COUNCIL ASSESSMENT REPORT

Panel Reference	PPSSNH-381
DA Number	LDA2023/0081
LGA	City of Ryde
Proposed Development	<p>Part demolition, alterations, additions and use of the premises for the purpose of a Waste or Resource Transfer Station for scrap metals. The proposed activity is classified as 'Designated Development' pursuant to Schedule 3 of the Environmental Planning & Assessment Regulation 2021.</p> <p>The proposal was also classified as 'Nominated Integrated Development', requiring a referral to the NSW Environmental Protection Authority, as a 'Scheduled Activity' in which the operator is required to obtain an Environment Protection Licence, pursuant to Sections 43(b), 48 & 55 of the Protection of the Environment Operations Act 1997. The NSW Environmental Protection Authority has considered the proposed development as below the threshold that would require an Environment Protection Licence.</p>
Street Address	50 - 52 Buffalo Road, Gladesville

Report prepared by	Sohail Faridy, Senior Coordinator Development Assessment
Report date	20 September 2023

Figure 3 – Demolition Plan

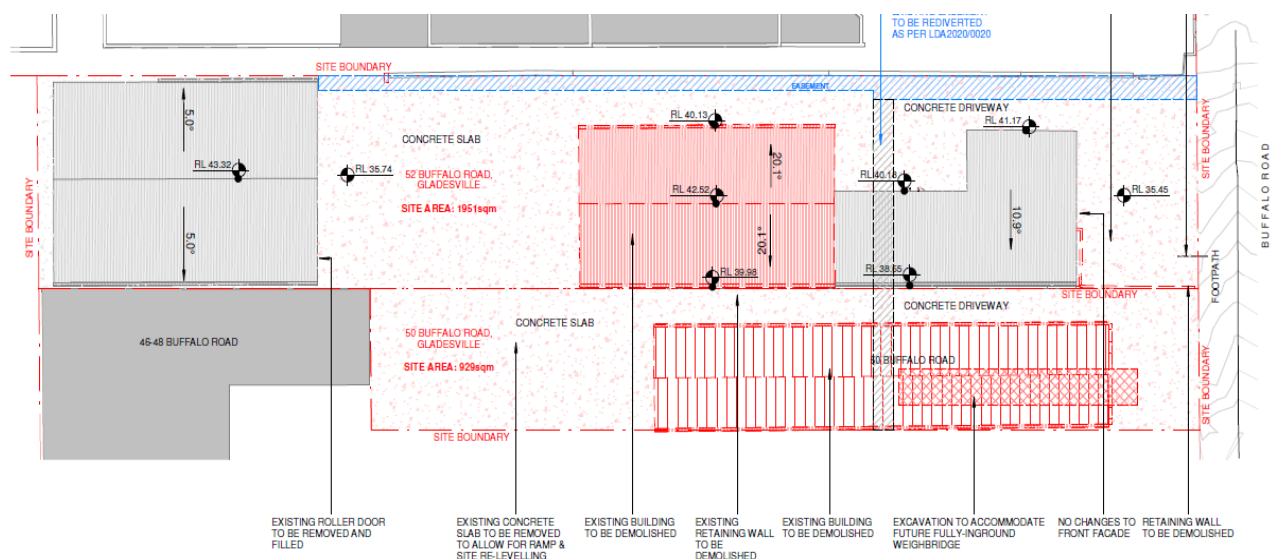
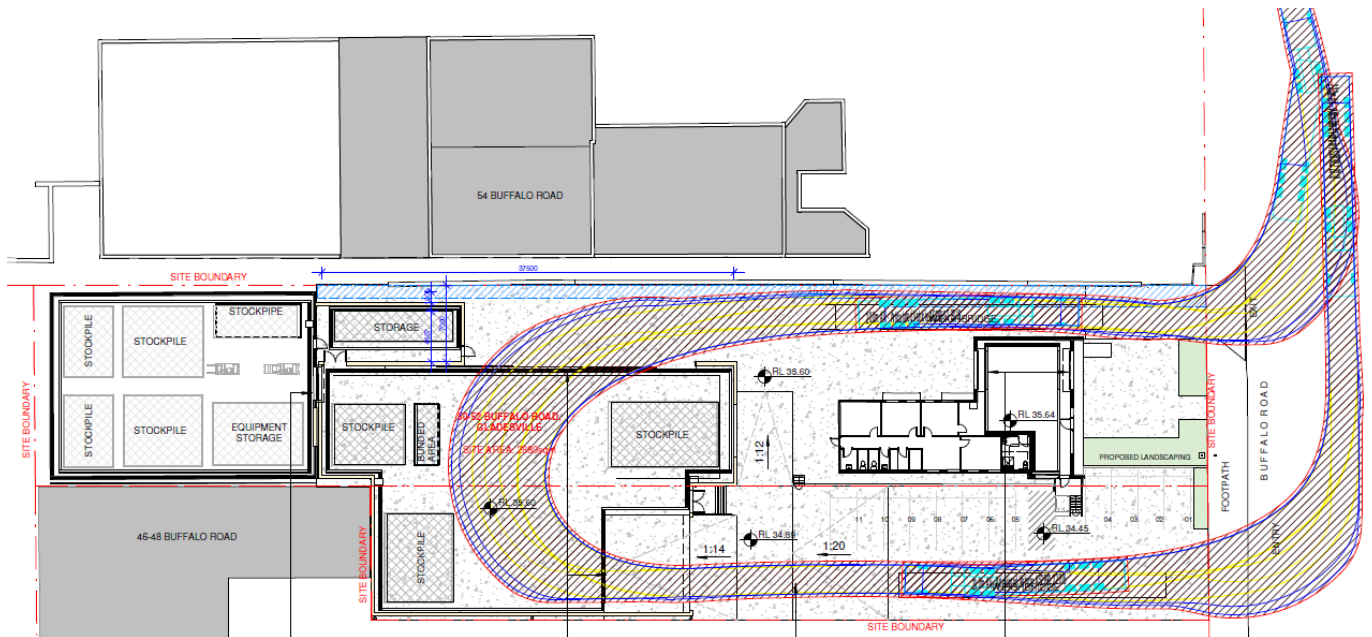
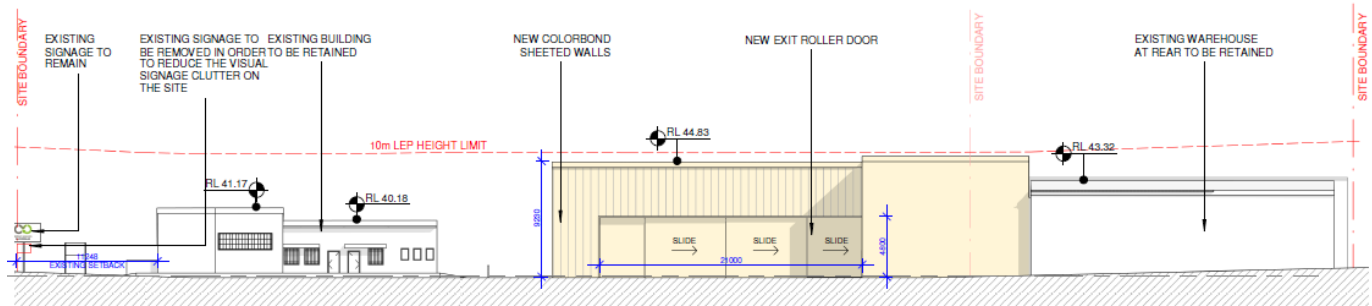
No signage is proposed as part of this development application. The information submitted with the development application indicates that the existing signage will be replaced with new signage through a separate approval process. The architectural plans however still indicate several signs to be retained on the site.

8. There is no design detail of the proposed onsite detention system (OSD).
9. The proposed northern weighbridge encroaches upon the easement to drain water. A written consent has not been provided by the beneficiary of the easement supporting the encroachment.
